Urgent Field Safety Notice (FSN)

Replacing the power supply unit
for care beds in the Ecofit Xtra range

23.04.2024

Plug-in power supply SMPS - PS1102
200-240V, 50-60Hz, 2,4A, IPX6
Model number: 503605

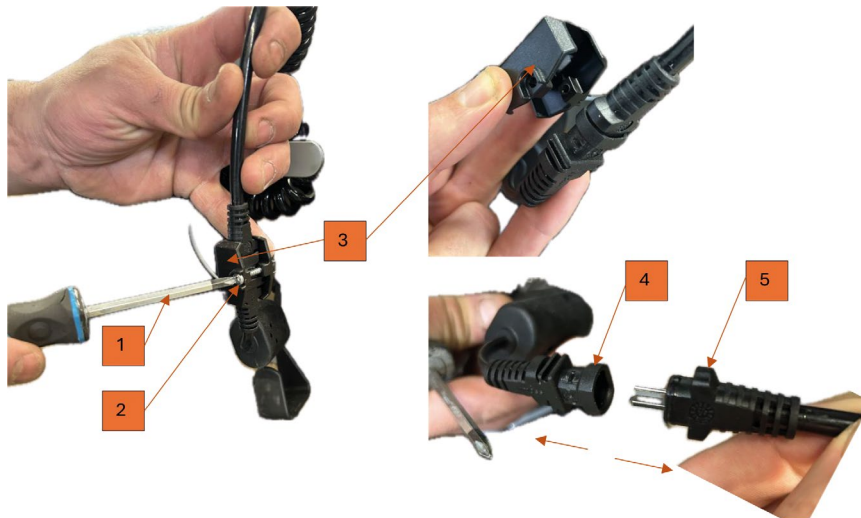
In ongoing tests by an external test institute, it was determined that there is a possibility of exceeding the standardized limit value for conducted emissions. This can occur in load scenarios of a high load in the range of the maximum patient weight.

Please replace the MC115L-90-EU power supply unit with the PS1102 power supply unit provided free of charge by tecfor care for care beds from the Ecofit Xtra range in your inventory or during the next maintenance. Instructions for replacement can be found in the appendix to this letter.

1. To remove the previously installed power supply unit, use a screwdriver (1) to loosen the screw (2) on the safety cap of the plug connection.
2. You can then remove the protective cap (3) with little effort.
3. Now release the plug connection (4+5) by pulling in the opposite direction.

1. Take the new plug from the scope of delivery and fit it in the opposite direction as described in the "Disassembly" section.
2. Once steps 3-1 have been carried out, the power supply unit is ready for use and can be reconnected to the mains supply.
